## Industrial Area Sampling and Analysis Plan

June 2001

## **EXECUTIVE SUMMARY**

Figure 15  
AOC Determination

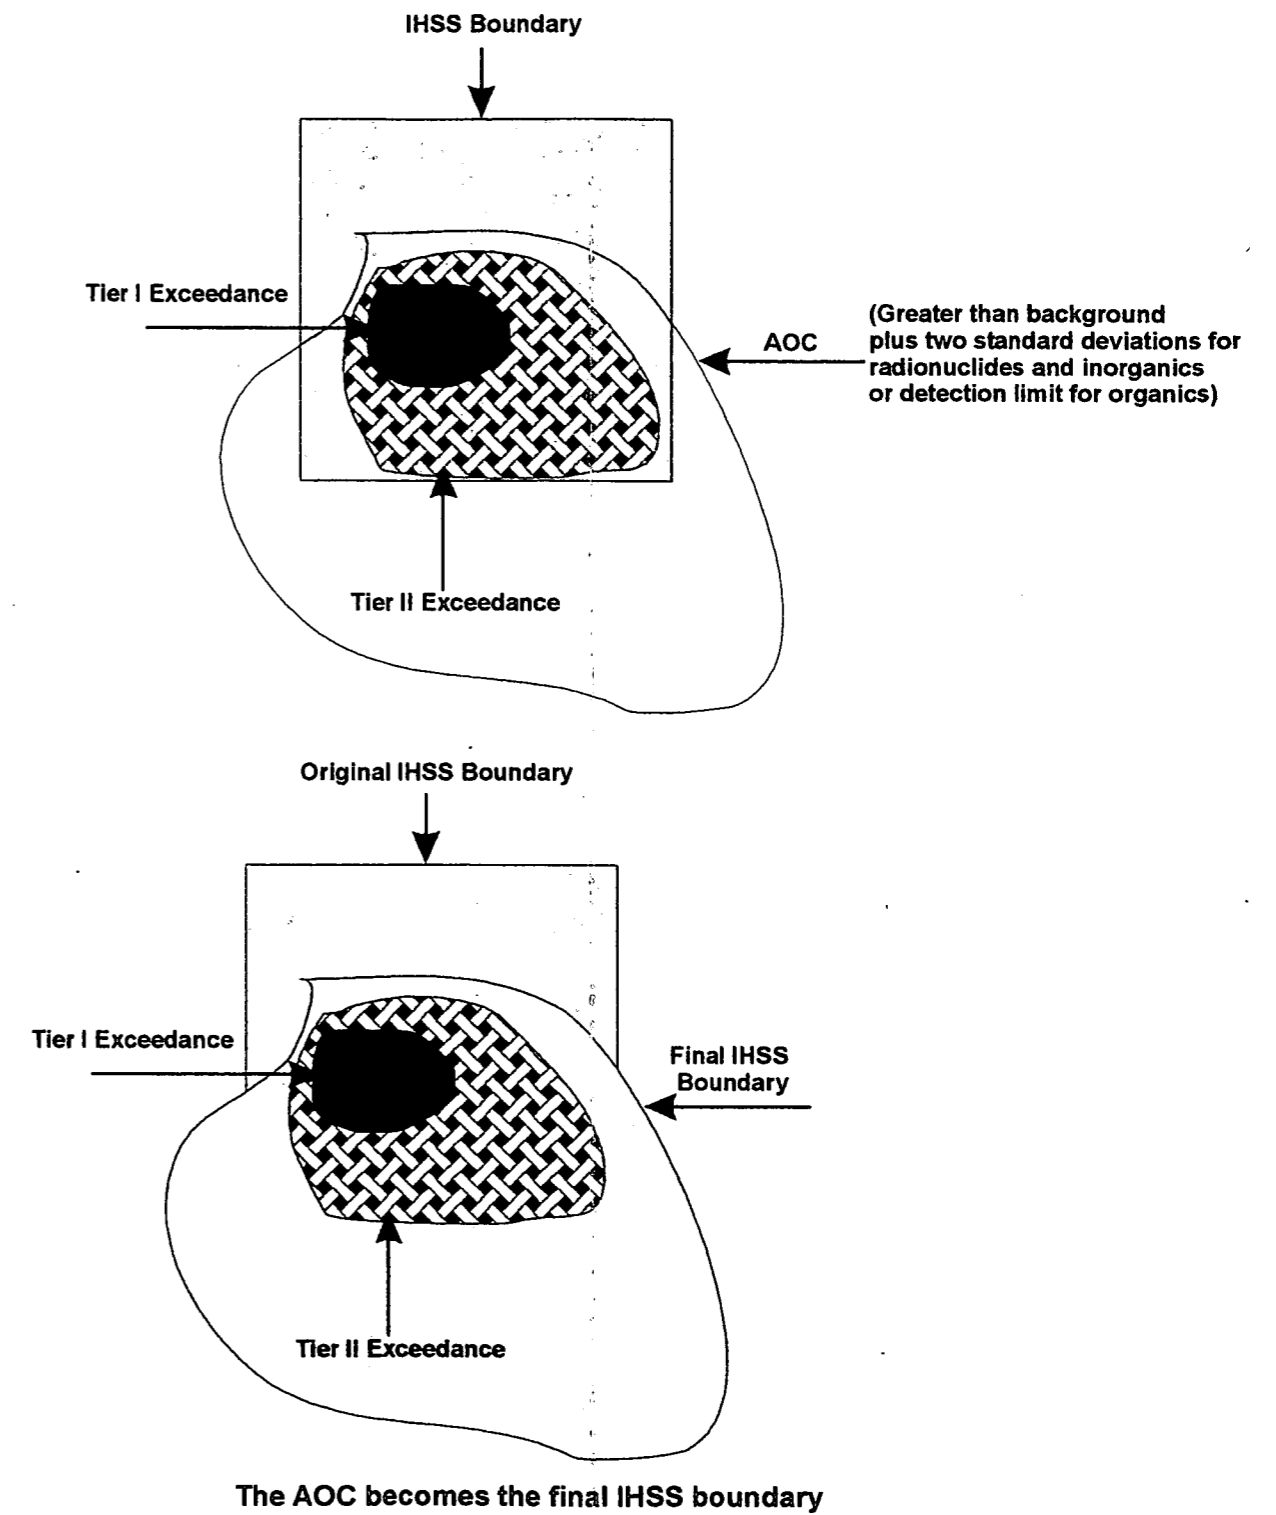
30	Figure 15 - It isn't clear why the initial input (blue box) is limited to "characterization sample analytical results". Won't confirmation sampling, plus any characterization sampling for areas where no remediation was necessary be the inputs here? Most of the characterization sampling	The initial input box has been changed to include existing analytical data as well as confirmation data.

**Figure 17**  
**Characterization Sampling Data Quality Assessment Logic Flow Diagram**  
**Decision: Determine the Nature and Extent of Contamination in IHSSs, PACs, and UBC Sites**

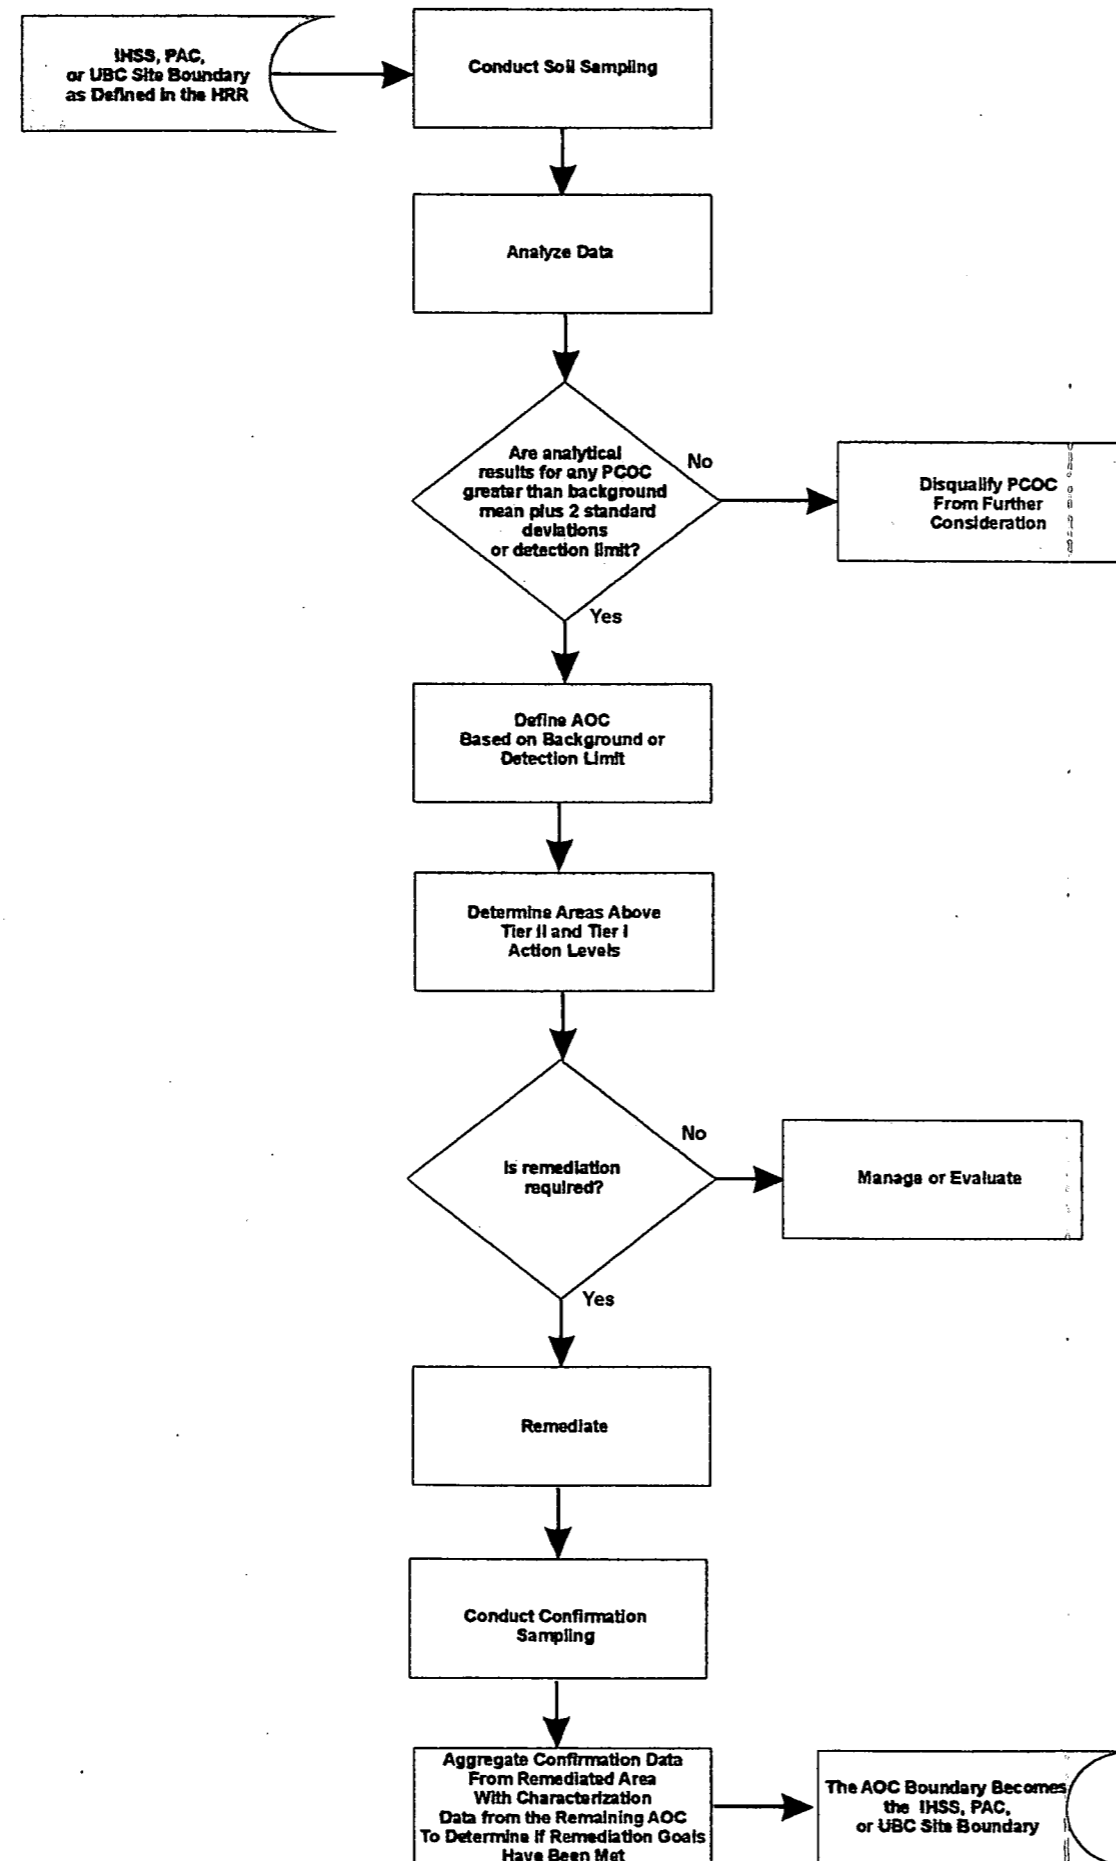
will no longer represent the area where remediation has occurred since the locations will no longer exist.	
31	<p>Figure 17- What are the inputs to this decision? In evaluating the remedial locations the cost to remediate to an ALARA level should be included in the decision.</p> <p>A) The NFA circles at the top of this flow diagram should be revised so they are consistent with the first two corresponding steps of Figure 18.</p> <p>B) The criteria for how the decision is made that "the data indicate a hot spot" needs to be specifically listed, e.g., spatial distribution, concentration &gt; DCGL<sub>EMC</sub>.</p> <p>C) References to the text would make all of the flow diagrams most useful.</p>	<p>An input box has been added to this diagram. Remedial costs are included in the ER RSOP as is the decision of when and how much to remediate.</p> <p>A) Figure 17 has been changed to be consistent with Figure 18.</p> <p>B) Figure 17 is for SmartSampling. The hot spot decision diamond is used to flow potential hot spot data into the EMC as SmartSampling is not necessarily used for hot spot evaluation.</p> <p>C) In the final draft, the figures will follow the text and will not be at the end of the document.</p>

Figure 18  
PCOC to COC Transition

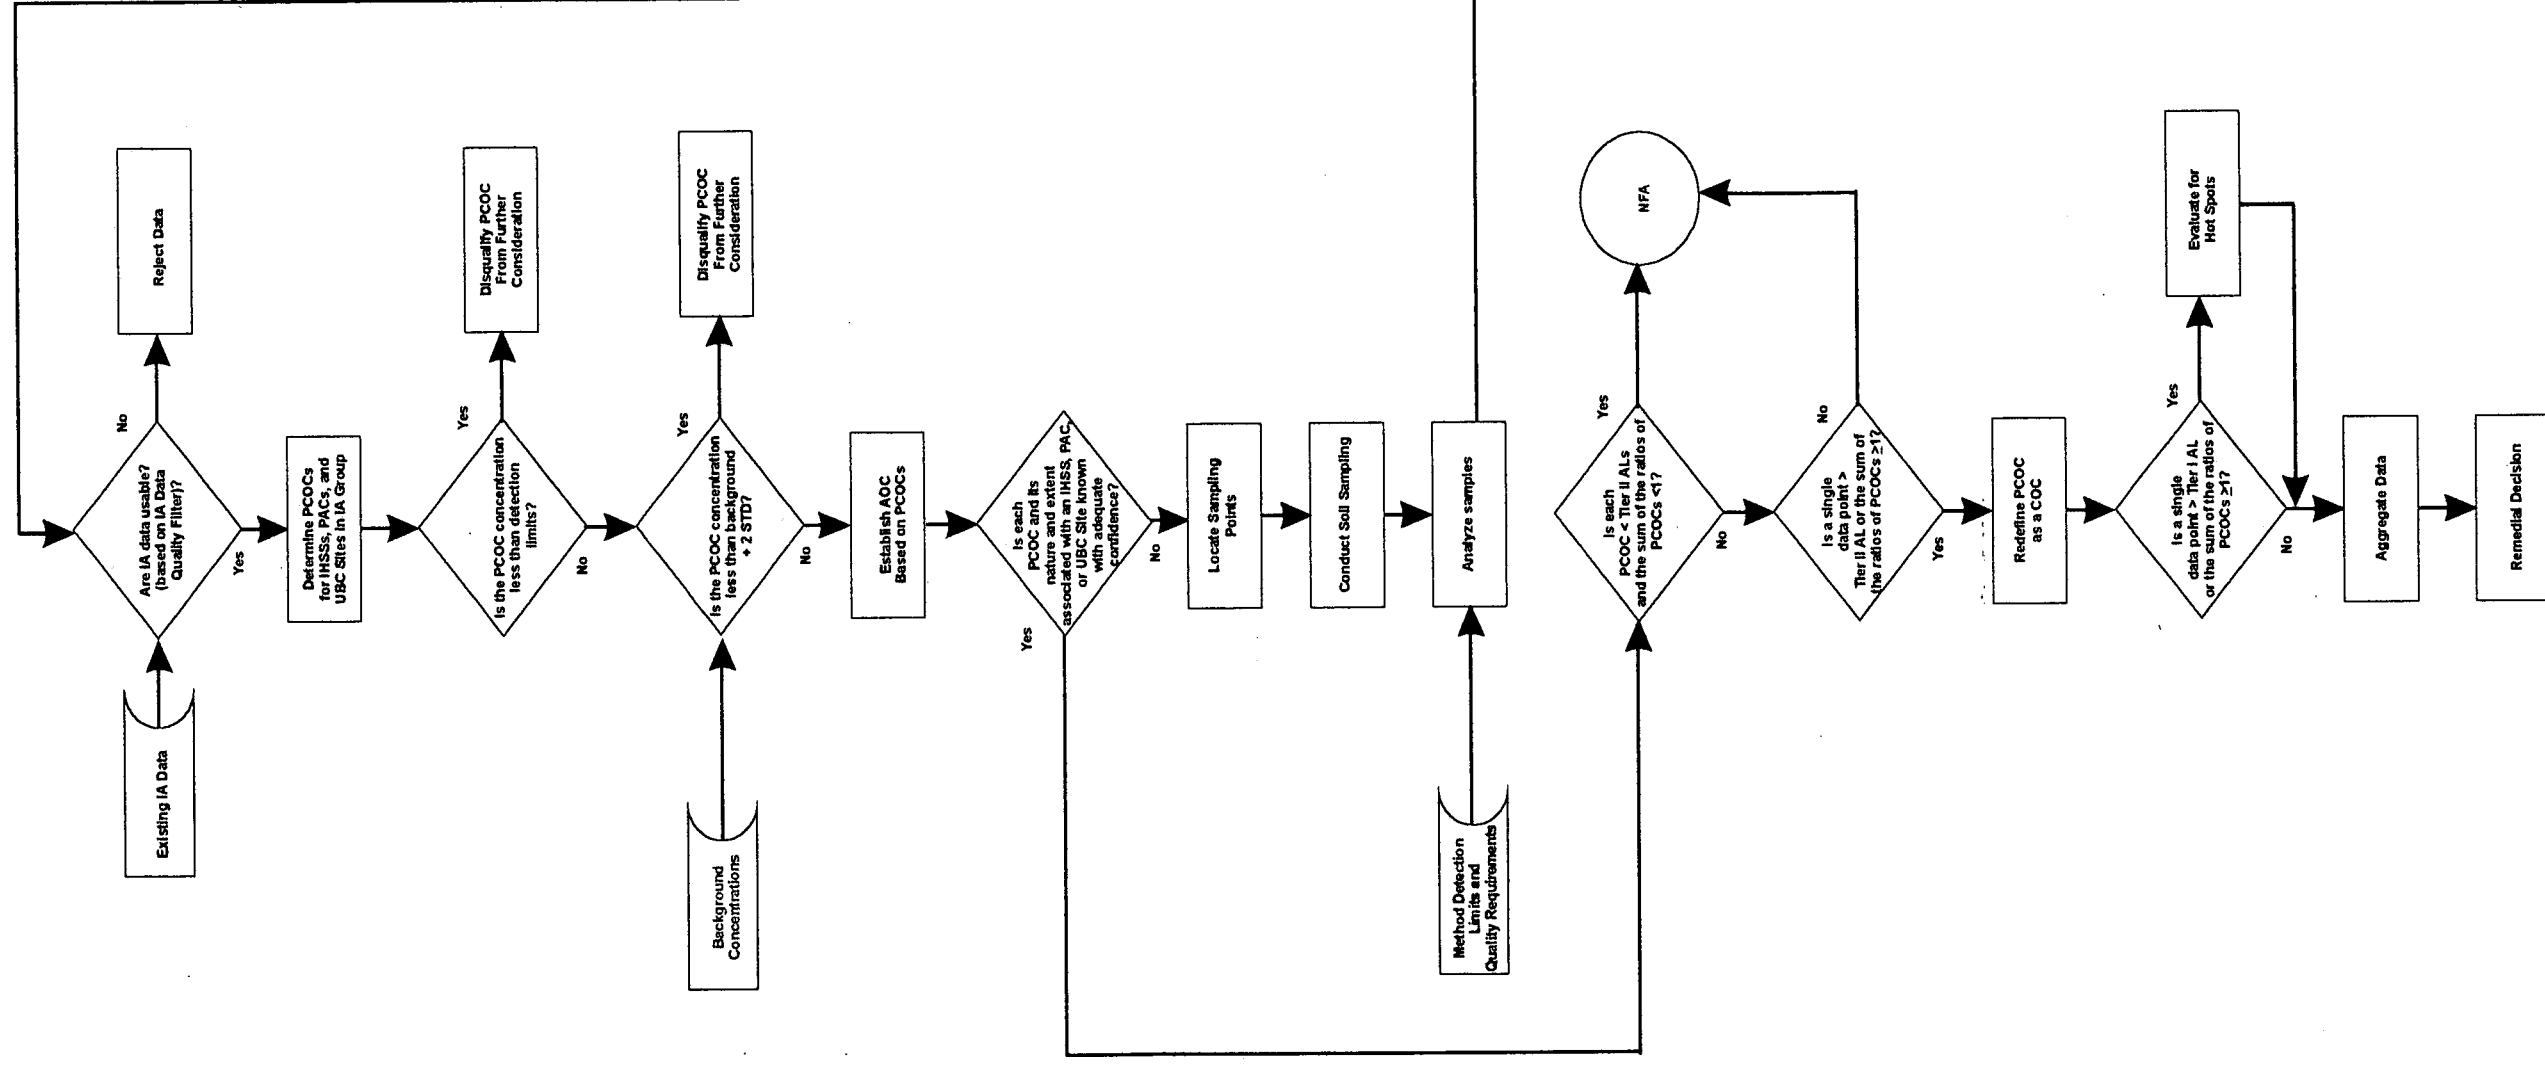
32	Figure 18 - uses PCOC and COC inconsistently.	The inconsistency was fixed.
<b>Comments on Appendix A, Draft Industrial Area Sampling and Analysis Plan Addendum Industrial Area Group 700-4</b>		
1	Page 1 Section 2.0 - The locations within Buildings 771 and 774 should be located on the reference map.	<p>Appendix A is included as an example of what an IASAP Addendum will look like. The IASAP Addendum for this IHSS Group will be based on building specific and existing data. An addendum for sampling within Building 771 is currently being developed.</p> <p>Figures 3 and 4 show where samples will be taken. Additional information on rooms within the buildings is UCNi classified.</p>
2	Page 11 Section 2.0 – The nitric acid dumpster is not identified on any maps, there is one biased sample just to	The nitric acid dumpster is considered part of Building 771.
